**Husky Exploration Drilling Project:  
Response to Information  
Requirements and Required  
Clarifications from Environmental  
Impact Statement Review**

Prepared for:  
Husky Energy

Prepared by:  
Stantec Consulting Ltd.  
141 Kelsey Drive  
St. John's, NL A1B 0L2  
Tel: (709) 576-1458  
Fax: (709) 576-2126

**ED-HSE-RP-0037**

**Figure 1 Husky Exploration Drilling Project Area and Study Area**

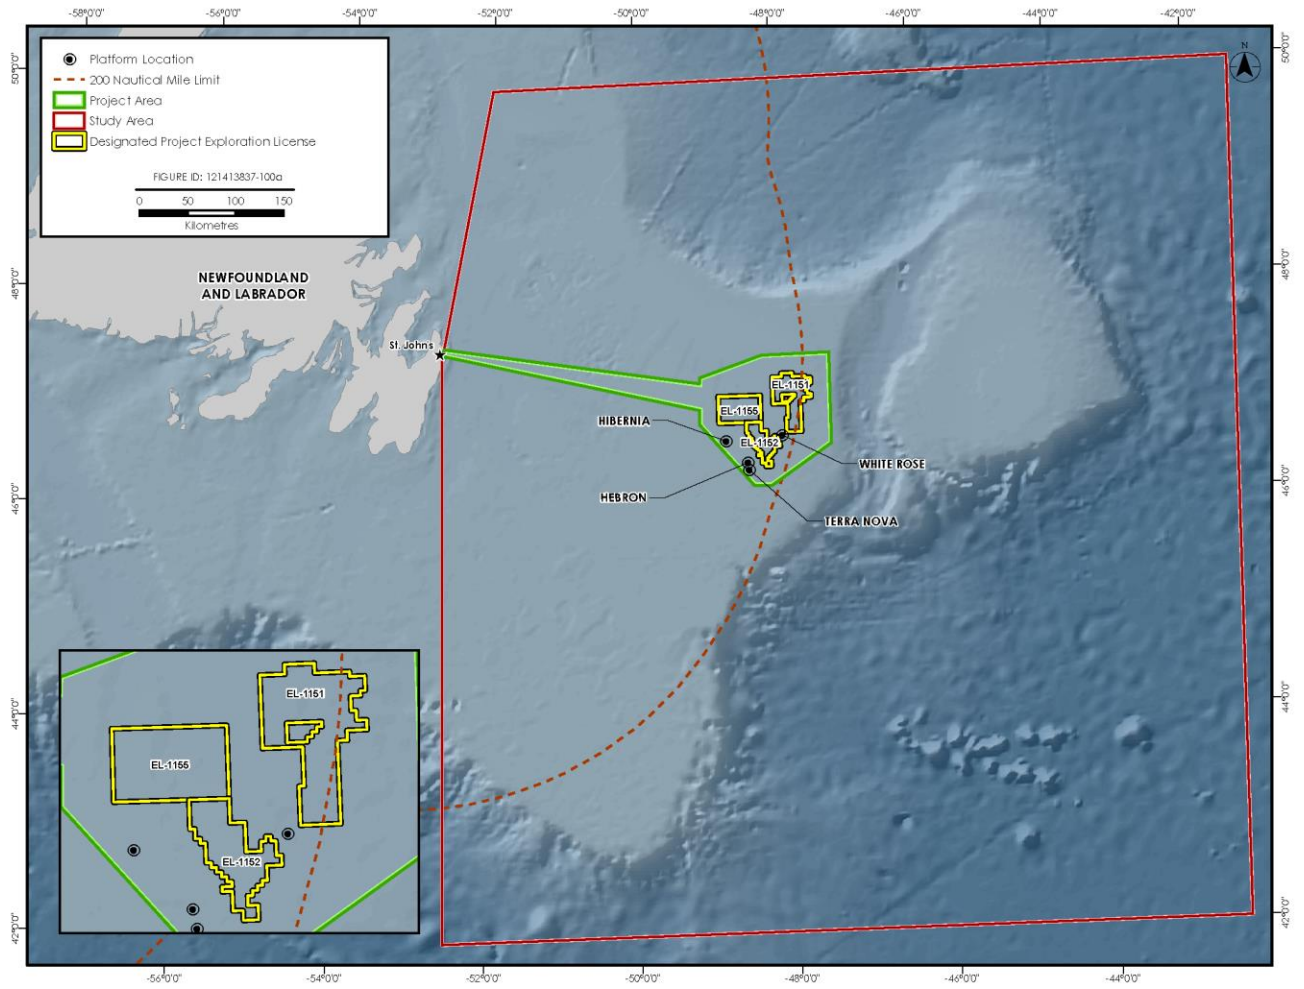
Figure 2.1 shows the project area boundary extending into the St. John's area, reflecting vessel routes. However, the study area does not extend to the Newfoundland coast and is therefore not inclusive of the entire project area. It is not clear how a study area that does not encompass the full project area considers the potential effects of routine shipping activities, as well as potential accidents and malfunctions in the nearshore environment.

The Study Area boundary has been corrected to be fully inclusive of the Project Area, by extending the Study Area to the Newfoundland coast (see Figure 1). The EIS has considered the potential effects of routine shipping activities, as well as potential accidents and malfunctions in the nearshore environment, where applicable.

**Figure 1 An Overview of the AZMP Cross-shelf Sections Related to the Project Area as well as Fixed Data Collection Station 27**

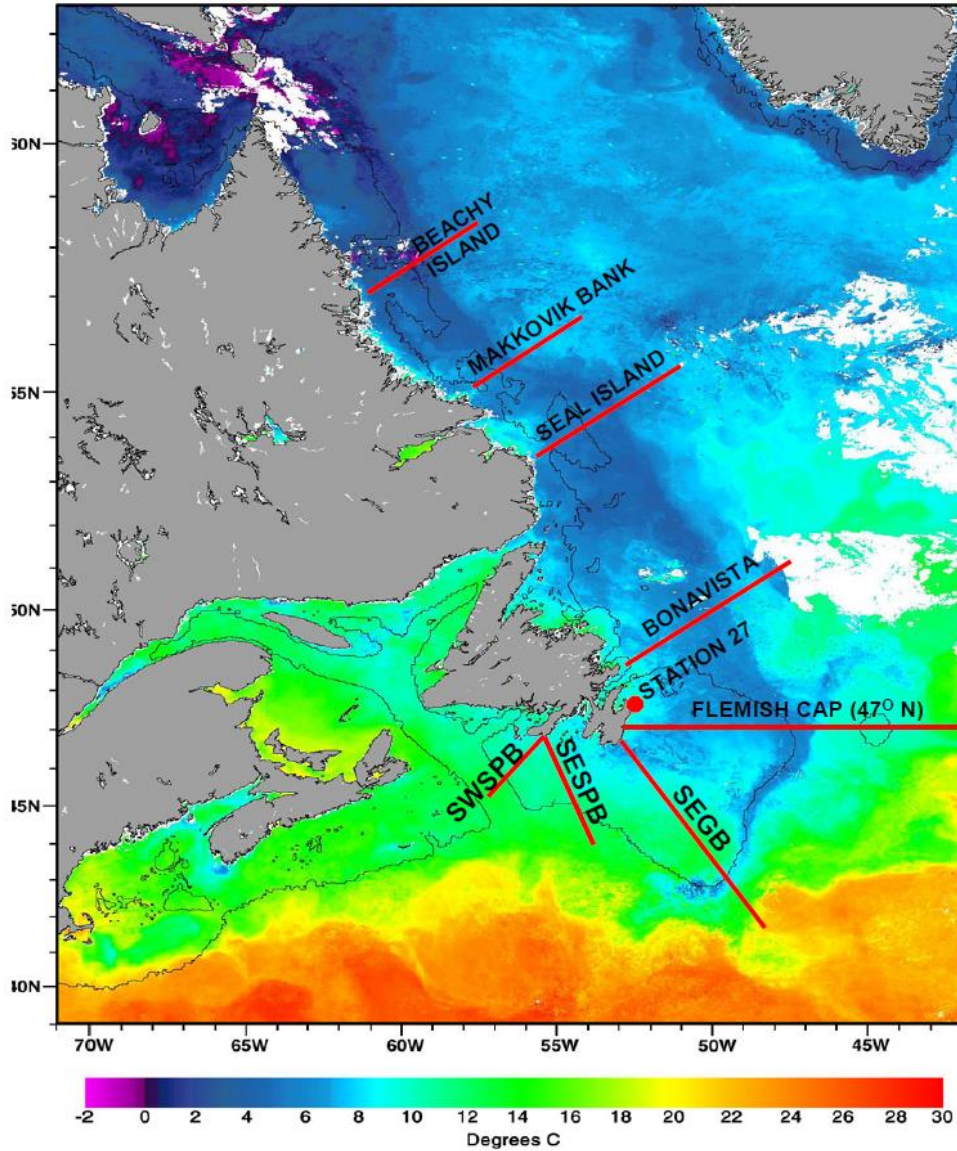
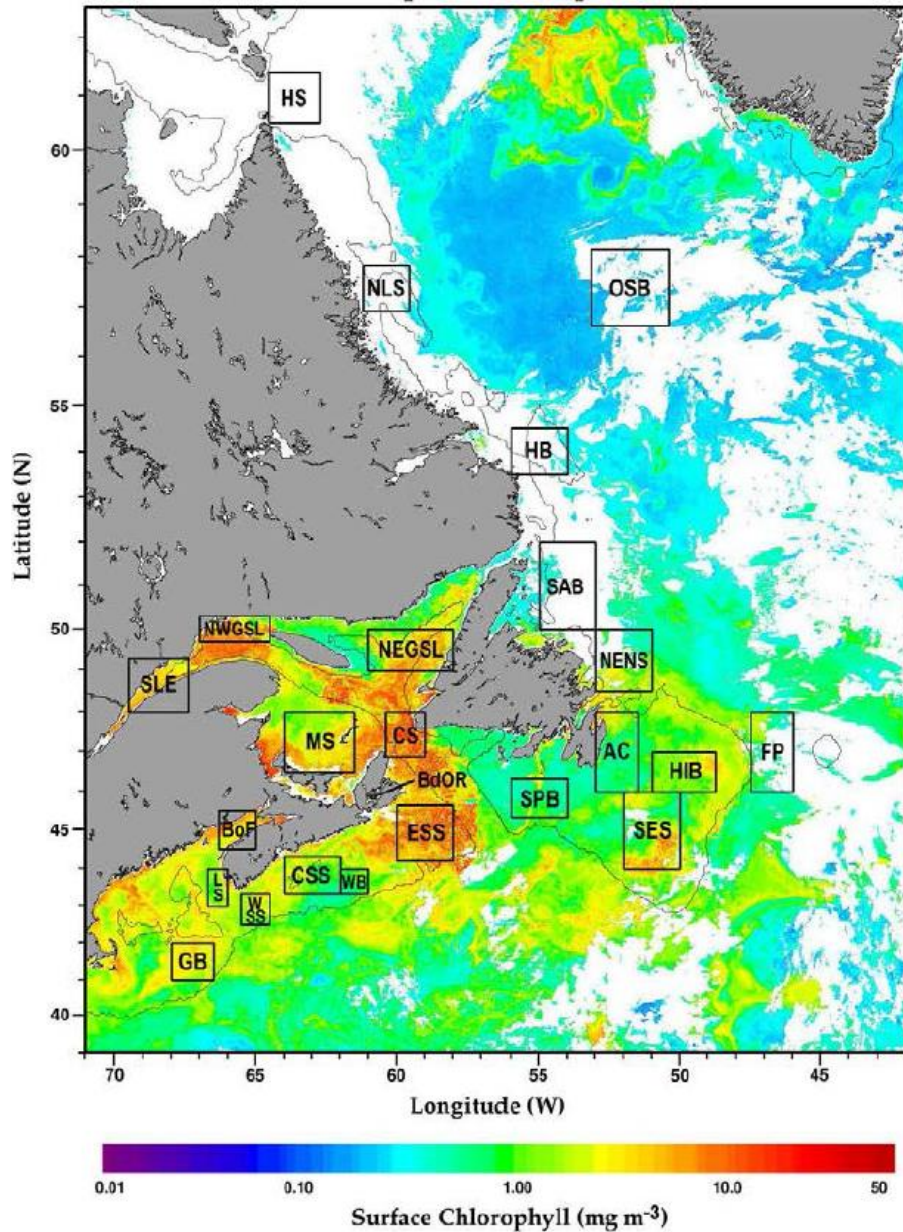
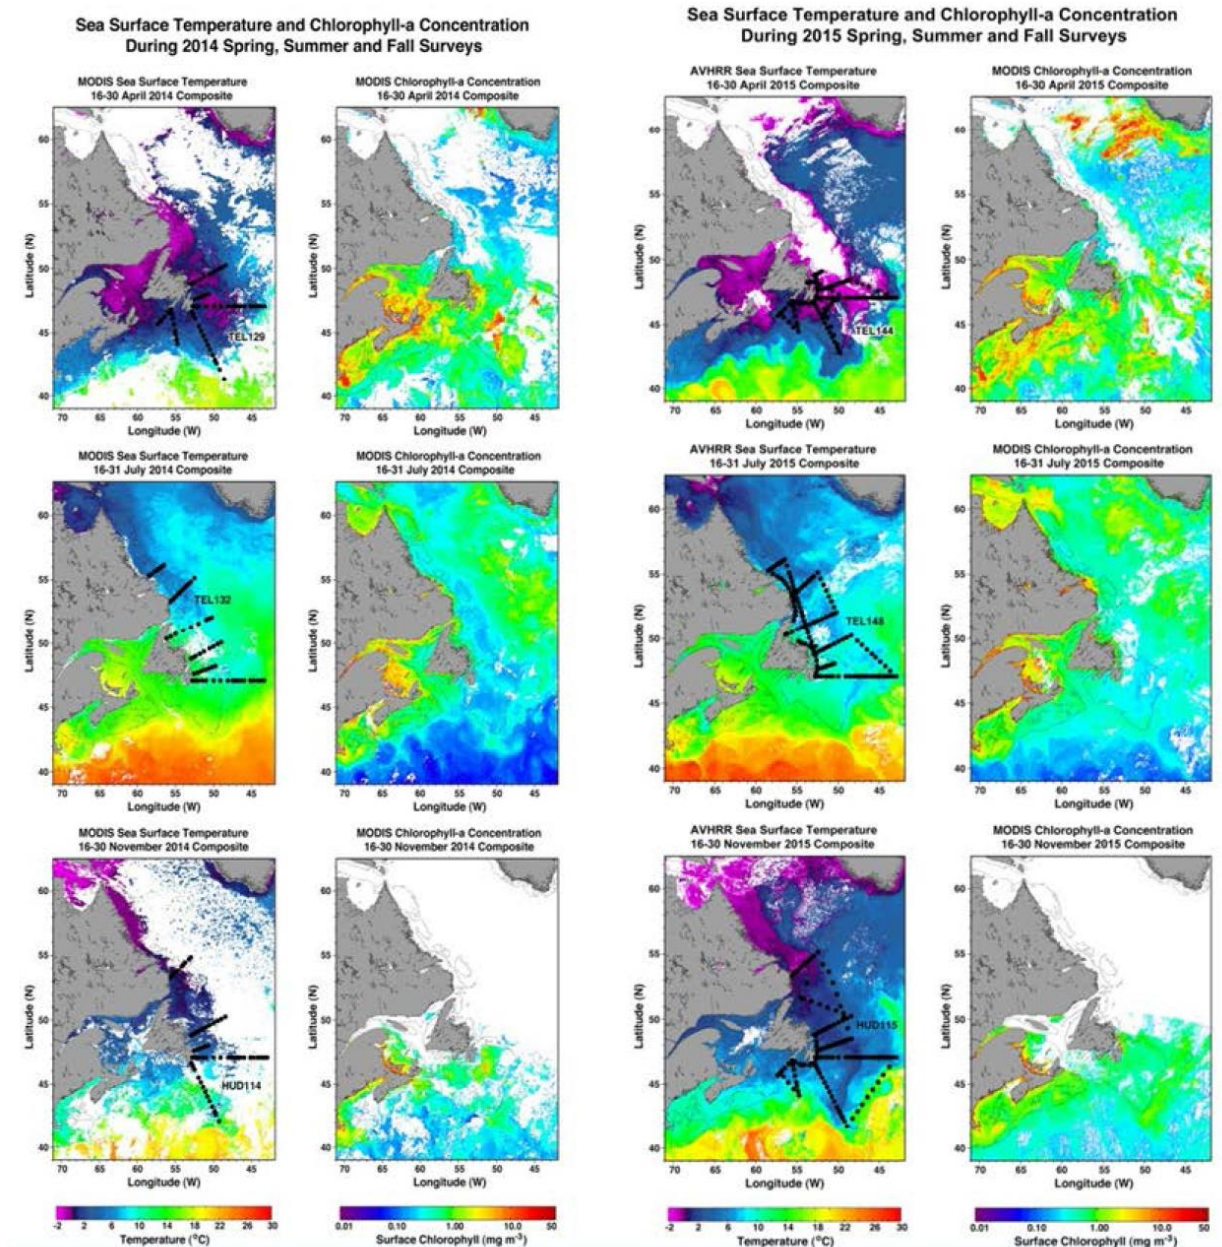
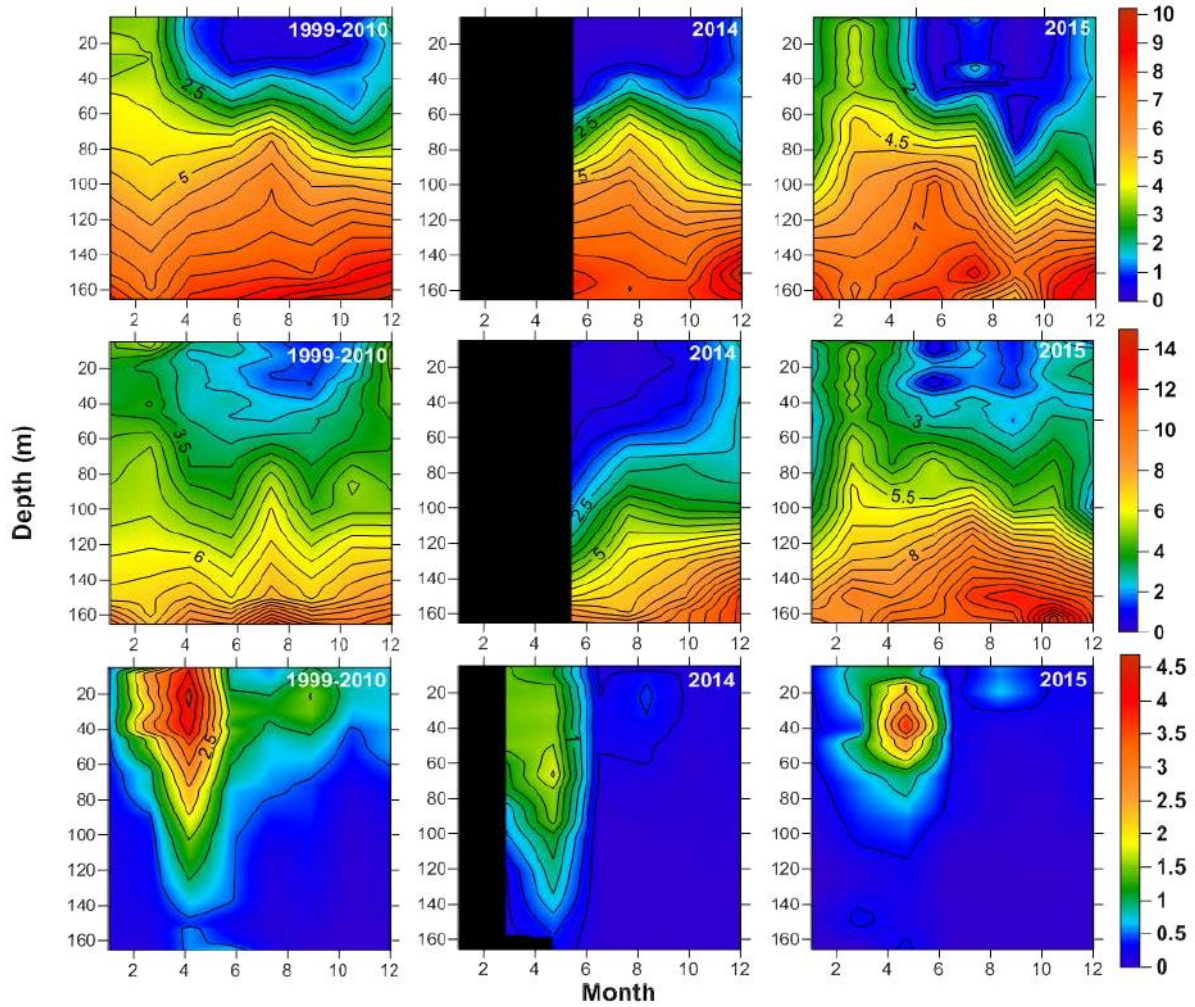
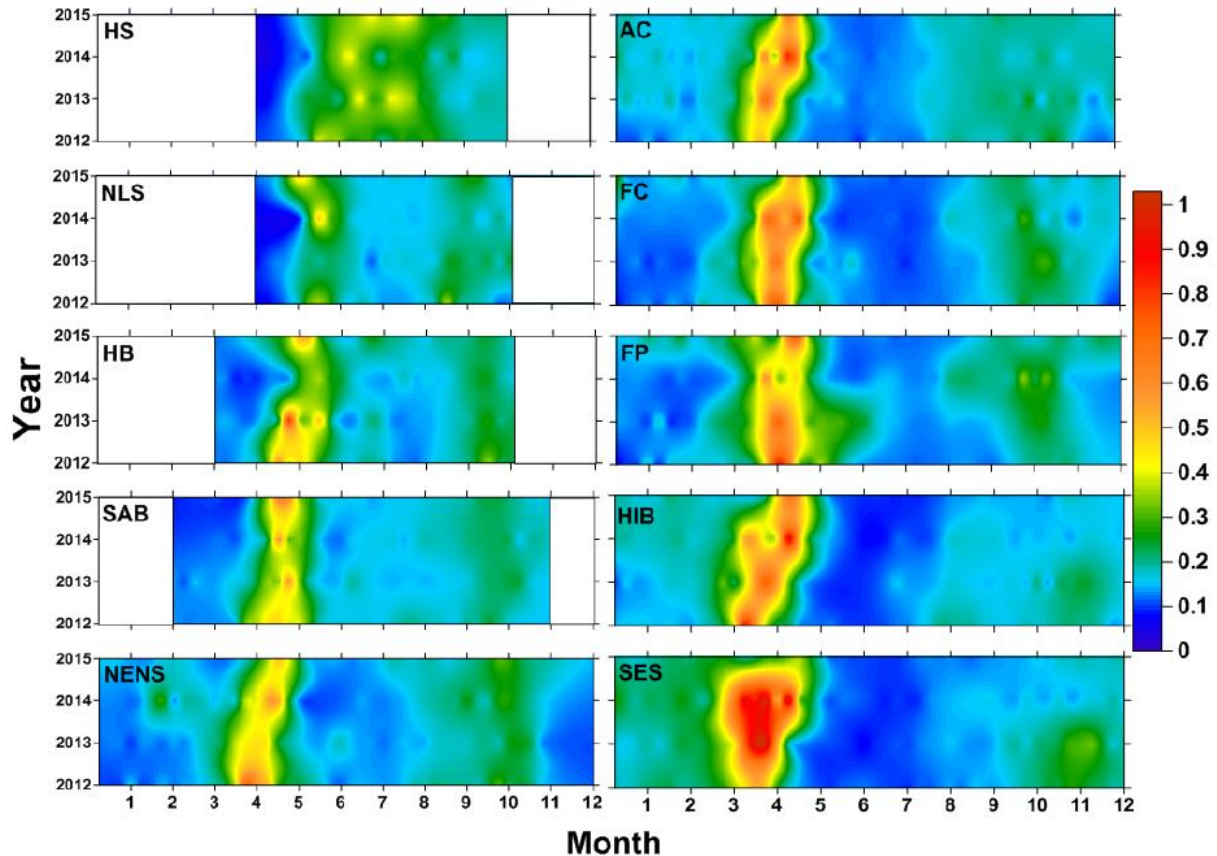
The seasonal distribution and abundance of phytoplankton (measured as chlorophyll a concentration) in the project area is not provided in the EIS.

Provide data showing the seasonal distribution and concentration of phytoplankton in the project area.

While chlorophyll-a concentration is not specified in the EIS, a description of phytoplankton and their seasonal trends are discussed in Section 4.2.1.2. Information pertaining to the distribution and concentration of phytoplankton and/or chlorophyll-a directly in the Project Area is limited. The most recent data for chlorophyll-a concentrations on the Newfoundland Shelf comes from the Atlantic Zone Monitoring Program (AZMP). Pepin et al. (2017) have described the biological oceanographic conditions on the Newfoundland shelf during 2014-2015 as well as historical mean conditions. The AZMP obtains its information on the state of the marine ecosystem from data collected at a network of sampling stations, which range from high-frequency sampling stations and cross-shelf sections, as well as groundfish surveys (Figure 1). The program also relies on the spatial and temporal analysis of satellite ocean colour data to produce sea surface chlorophyll-a concentrations (Figure 2).

Figure 1 Coral and Sponge Distributions within the Project Area with Specific Reference to ELS 1151, 1152, and 1155

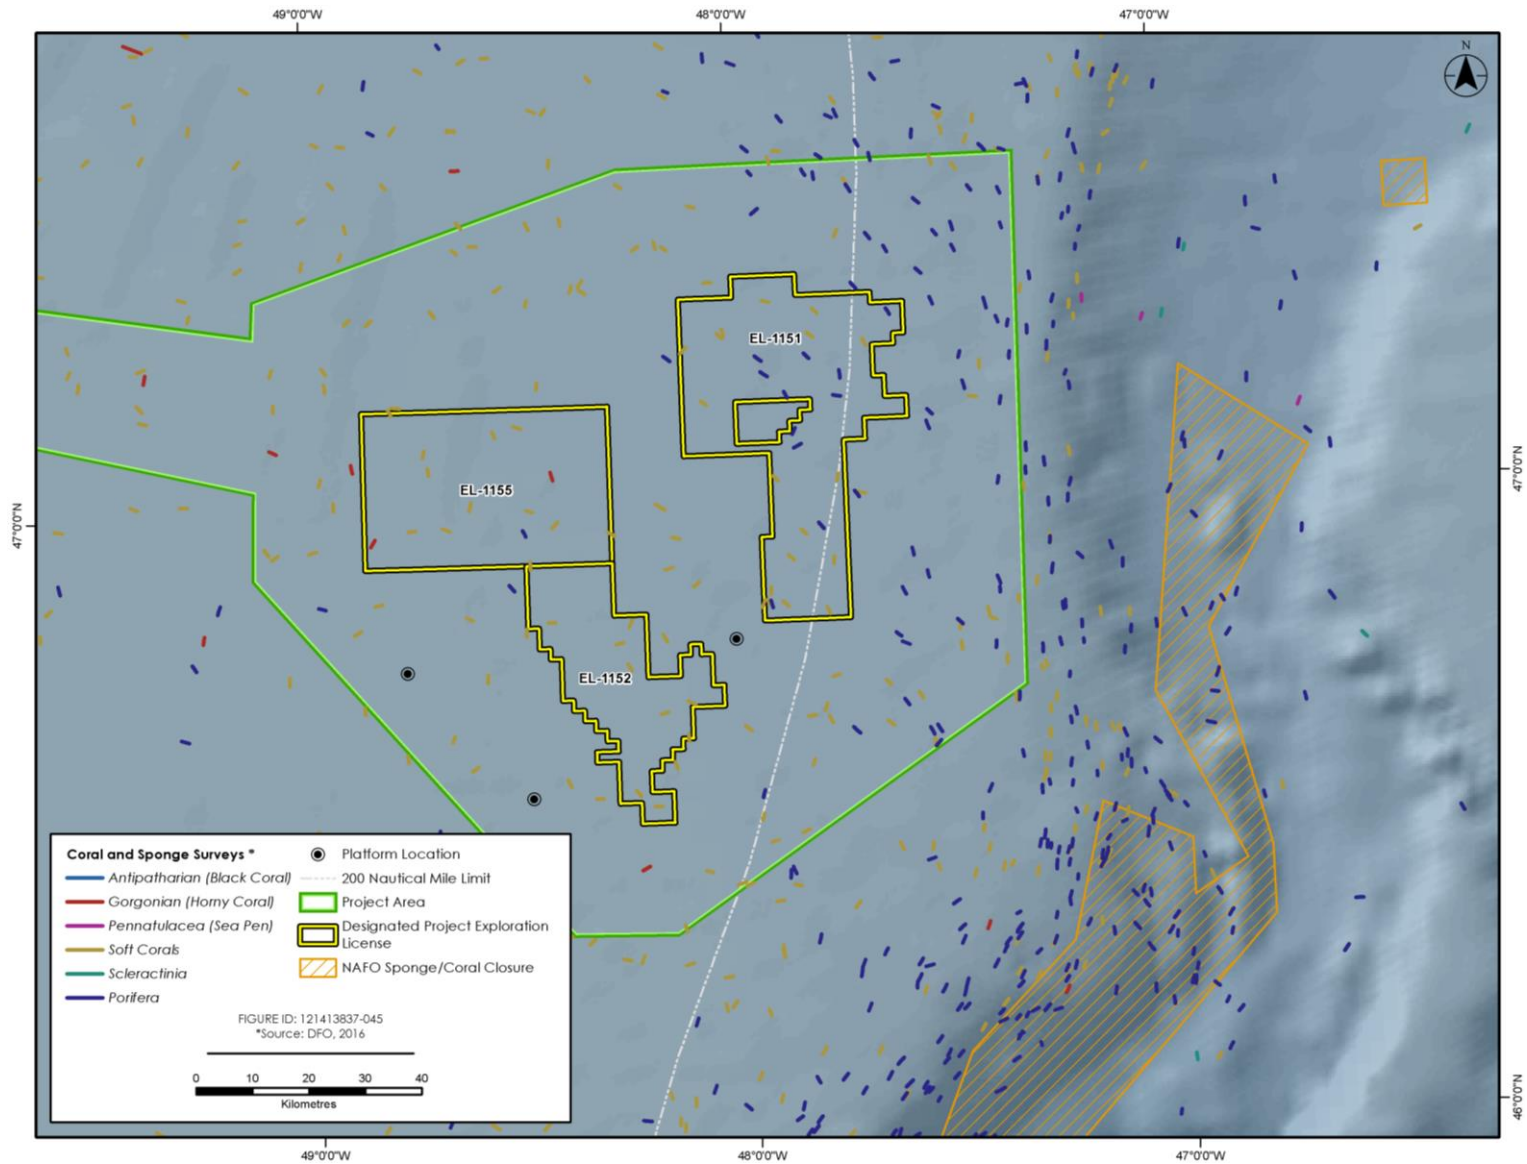
Figures 4.23-4.26 provide coral and sea pen recordings from various surveys on the slopes of the Grand Banks, in the Flemish Pass and around the Flemish Cap. However, the ELs for this Project are largely on the Grand Banks. Based on baseline information provided in Table 4.19, the EIS states that sensitive benthic organisms (i.e. coral and sponge species) have been collected by Canadian research vessel surveys and are present in ELs 1151, 1152, and 1155; however no corresponding figures are provided.

- *Asconema* sponges are not mentioned in the EIS. Refer to Murillo et al. 2016 for depth distribution information;
- some soft corals and *Acanella arbuscula*, a gorgonian coral, are also found on soft mud substrates; and
- Figure 4-25 should include small gorgonians (i.e., *Acanella arbuscula*) and recent North Atlantic Fisheries Organization (NAFO) data.

Figure 1 depicts data on coral and sponge species observed from within ELs 1151, 1152, and 1151 by Canadian research vessel surveys. Figure 1 also depicts all gorgonian corals (large and small) observed within and near, the Project Area. Descriptions of corals and sponge species outlined in Figure 1 are described in Section 4.2.3 of the EIS. It is noted that some soft corals and *Acanella arbuscular* can be found on soft mud substrates. Section 4.2.3 indicates that within the Study Area, corals and sponges are more abundant on the slopes of the Grand Banks and Flemish Cap at depths ranging from 600 to 1,300 m. This agrees with Guijarro et al. (2016), who indicate that sponge presence was highest between 1,000 to 1,500 m in depth. A literature review of F.J. Murrilo's published literature from 2016 failed to yield literature which specifically mentions *Asconema* sponges. Literature from 2016 indicates the observed and predicted location of sponge species in the Newfoundland and Labrador region, but does not specify species.
